ATLAS IRON WORKS ST. LOUIS, MO.	
Project:	WEBSTER ISB - MOCKUP A'
Customer:	PARIC CDRP
Owner:	WEBSTER UNIVERSITY
Location:	ST. LOUIS, MO
Dwn:	DC
Date:	6/16/16
Ckd:	
Date:	
Job No.	A16013-MU
BAT:	
DWG#:	MUA-E1

PROJECT: 15051-Webster University Interdisciplinary Science Building

RE: Structural Steel Mockup Shop Drawings
REV2

RE: Structural Steel Mockup Shop Drawings

PLAN VIEW

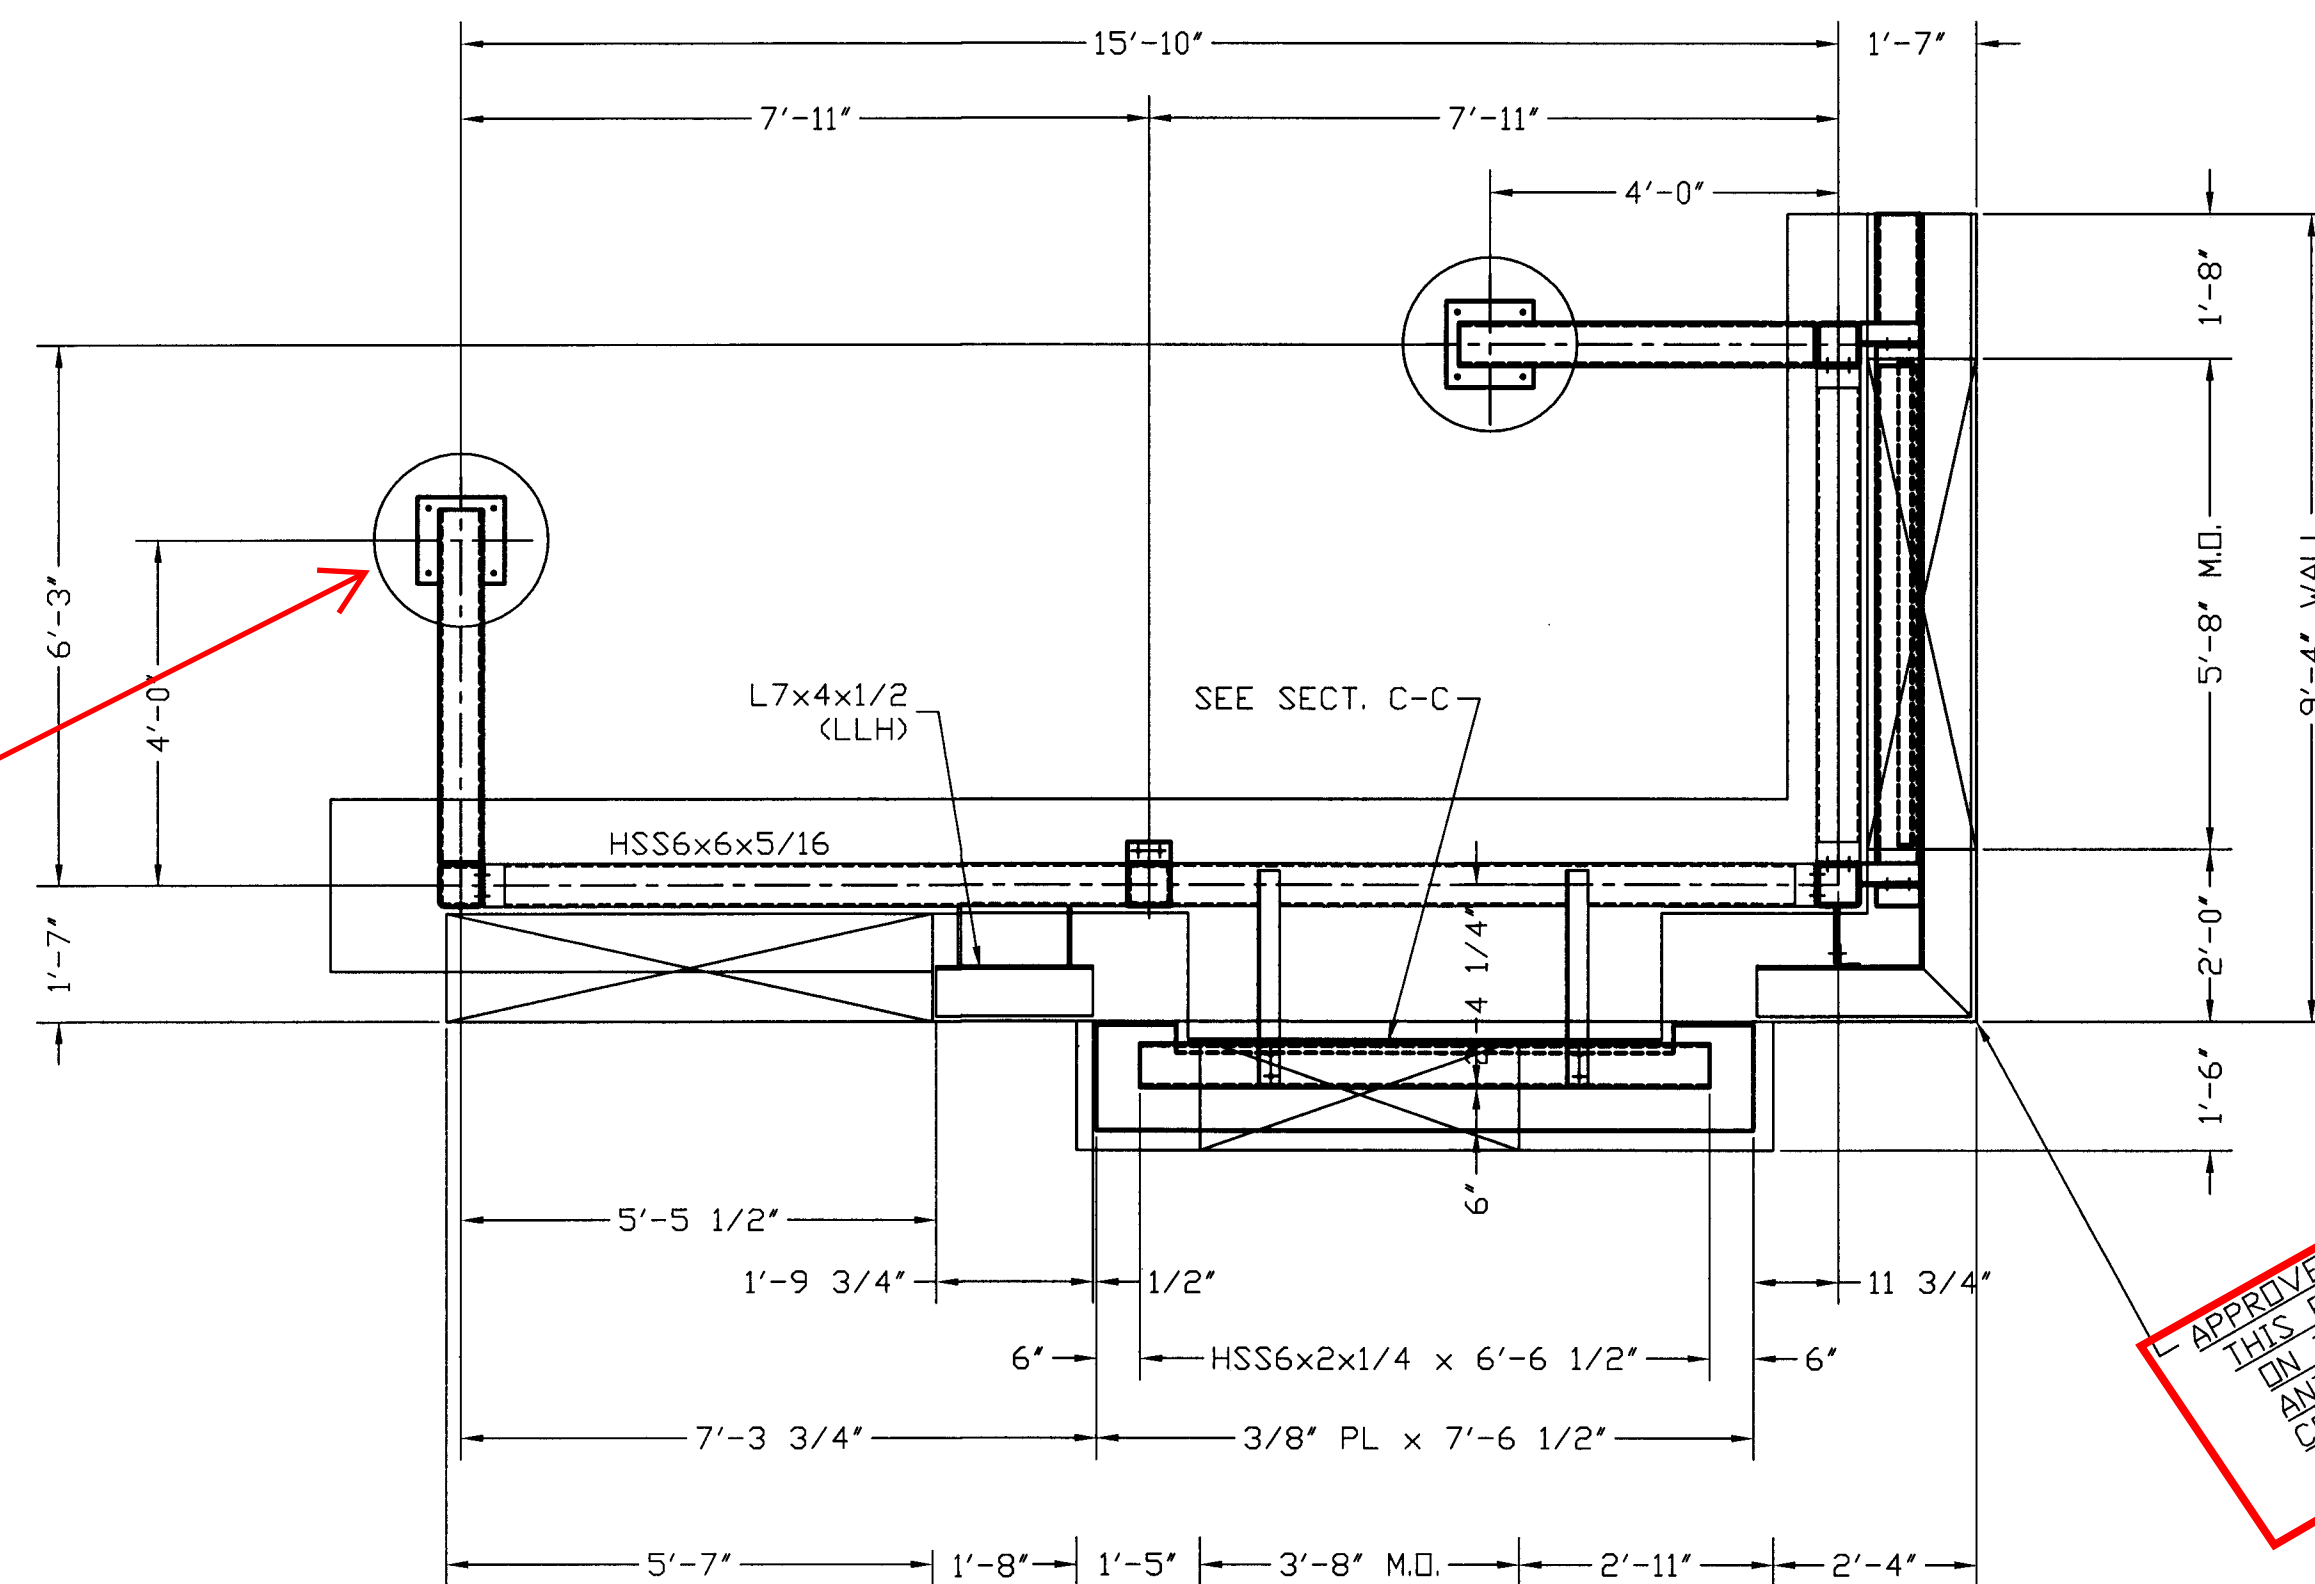
PROVIDE DETAILS OF ANCHOR BOLTS, INCLUDING SIZE, EMBEDMENT AND LAYOUT FOR TEMPLATE. TYPICAL. JYW/DMA

APPROVER NOTE:
THIS ENTIRE LAYOUT IS PREDICATED
ON THE CONCEPT THAT THE WALLS
AND FOUNDATIONS MATCH AT THIS
CORNER (PER 1/A0452)

ANCHOR PLAN

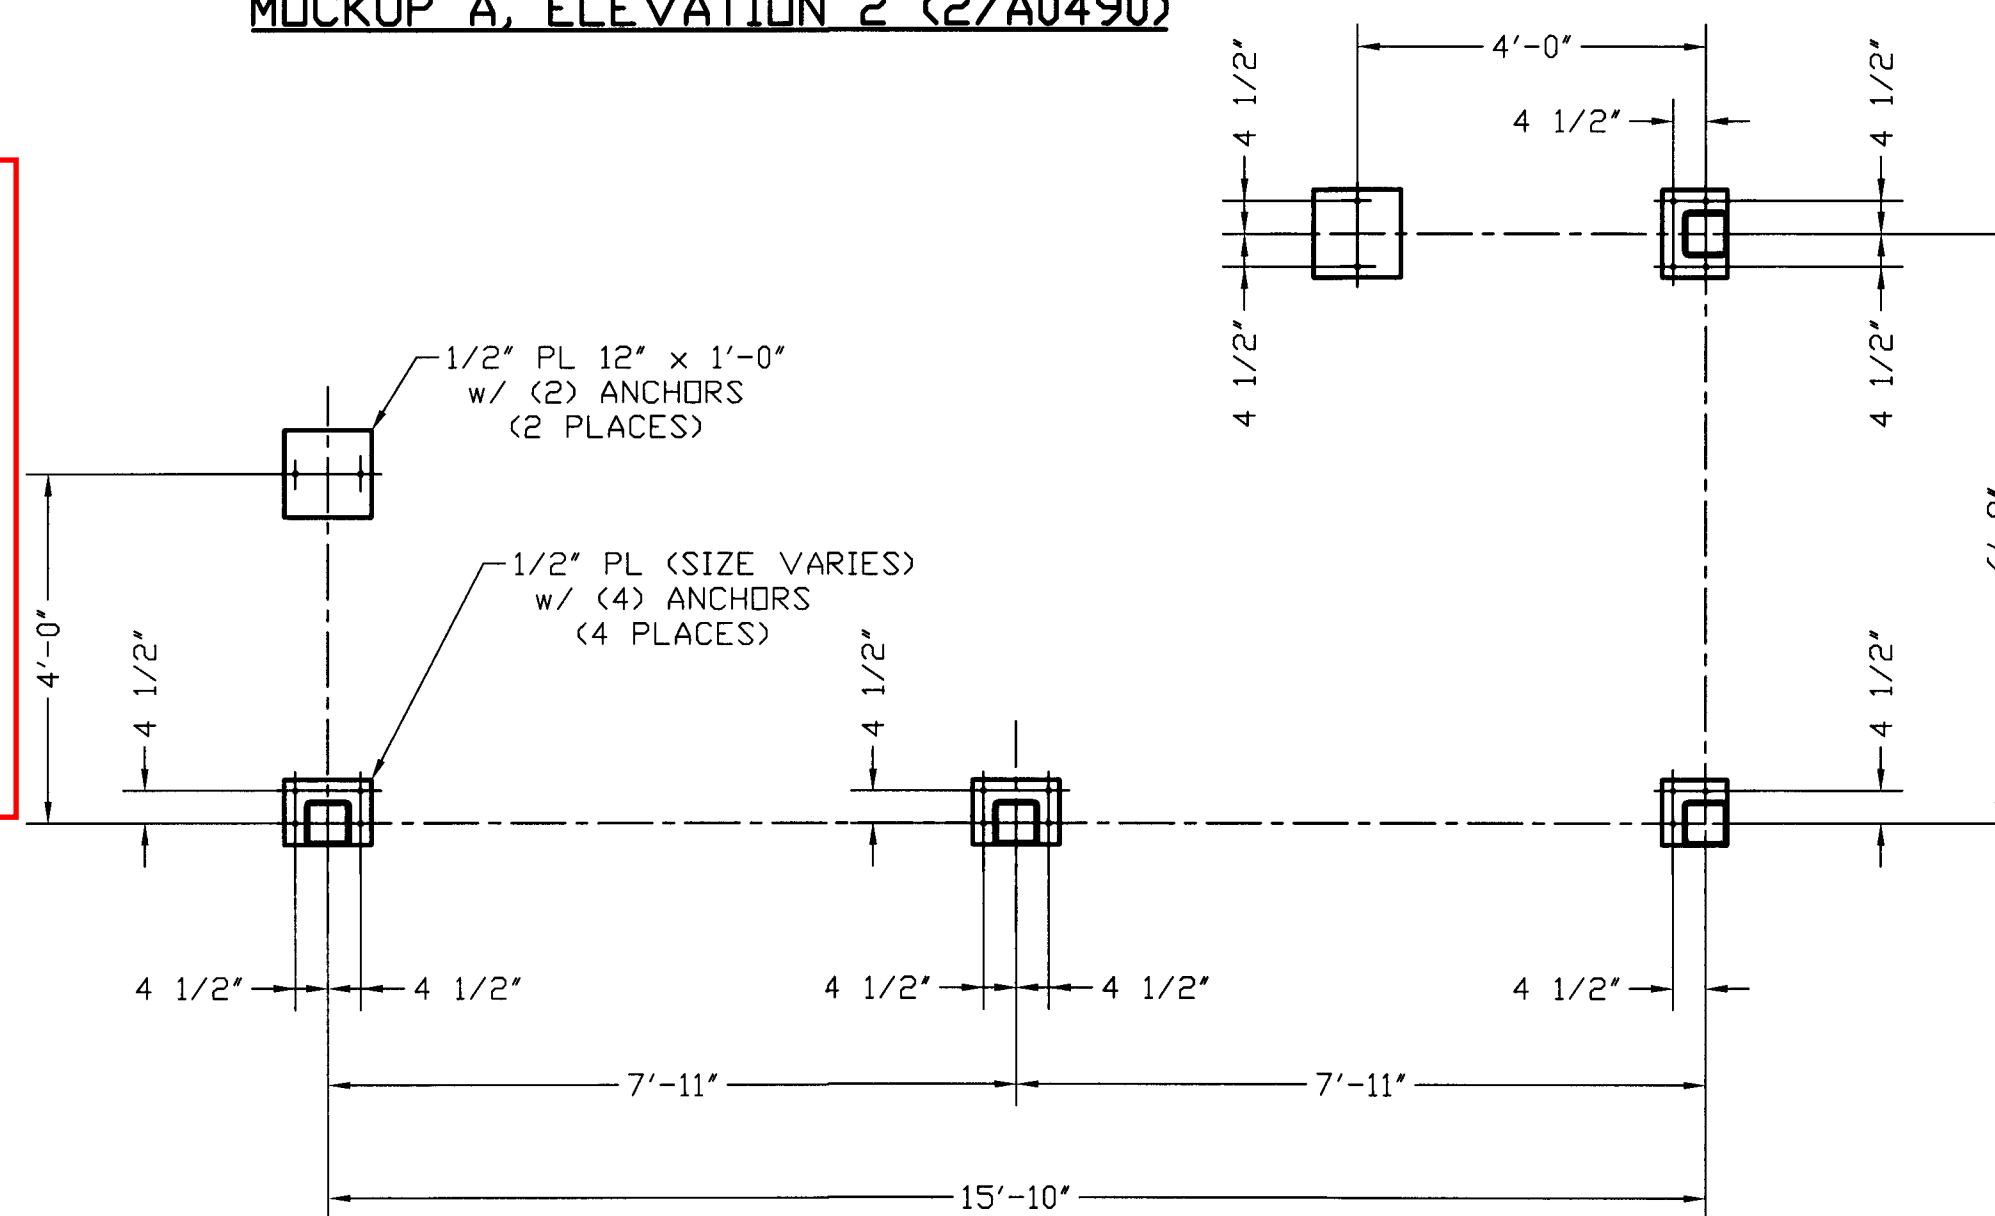
DESIGNER: PLEASE
PROVIDE DETAIL
FOR ANCHORING
STEEL

APPROVER:
~ PLEASE VERIFY DETAILS
~ PLEASE ADVISE ANCHOR DETAILS
~ PLEASE VERIFY GALVANIZING

PRIME PAINTED IS ACCEPTABLE
PER KELVIN PATEL

ANCHOR PLAN

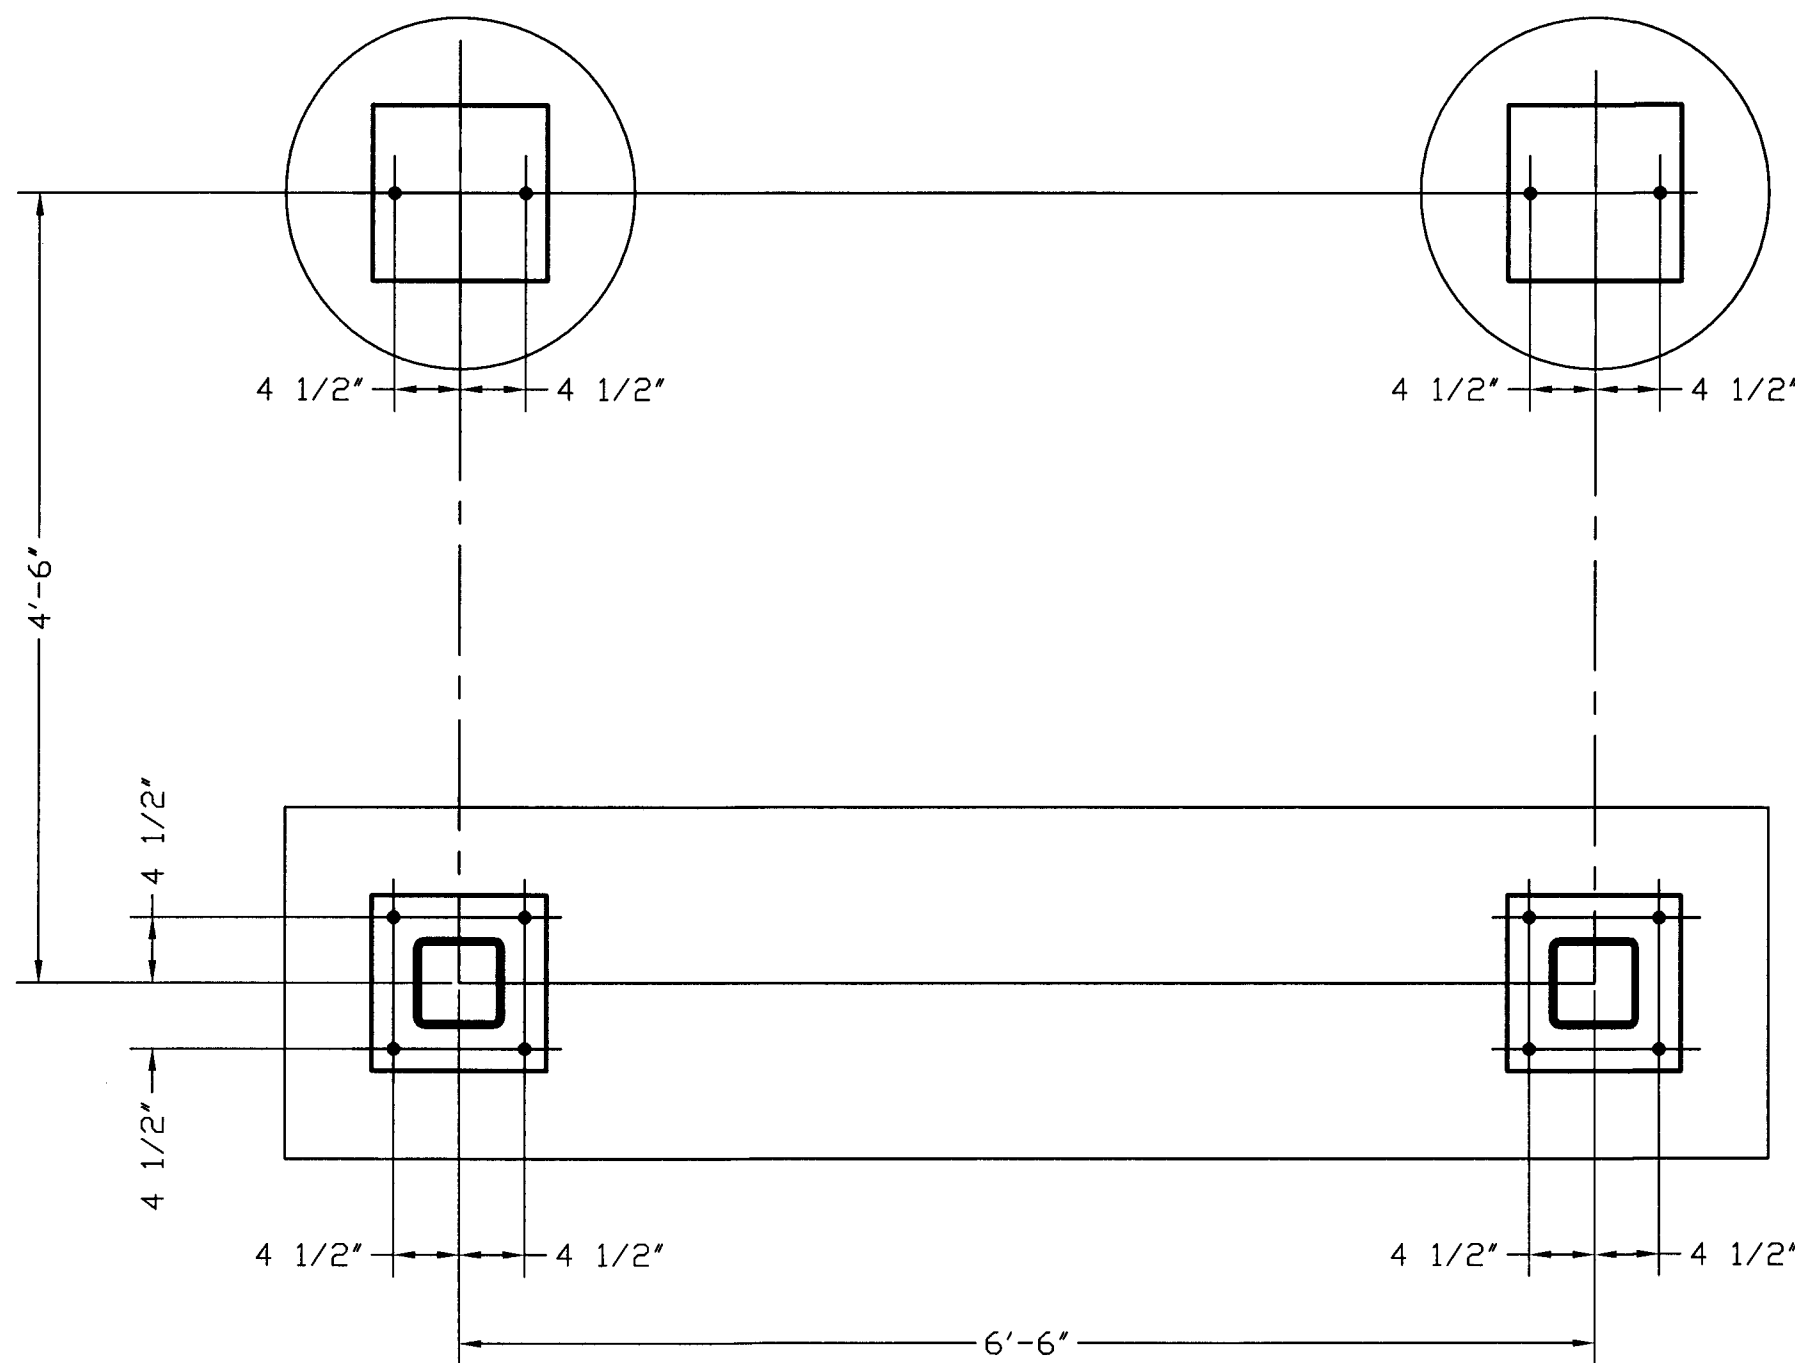
DESIGNER: PLEASE PROVIDE
ANCHOR REQUIREMENTS

APPROVER:
~ PLEASE VERIFY DETAILS
~ PLEASE ADVISE ANCHOR DETAILS
~ PLEASE VERIFY GALVANIZED?

PRIME PAINTED STEEL
ACCEPTABLE PER KELVIN PATEL
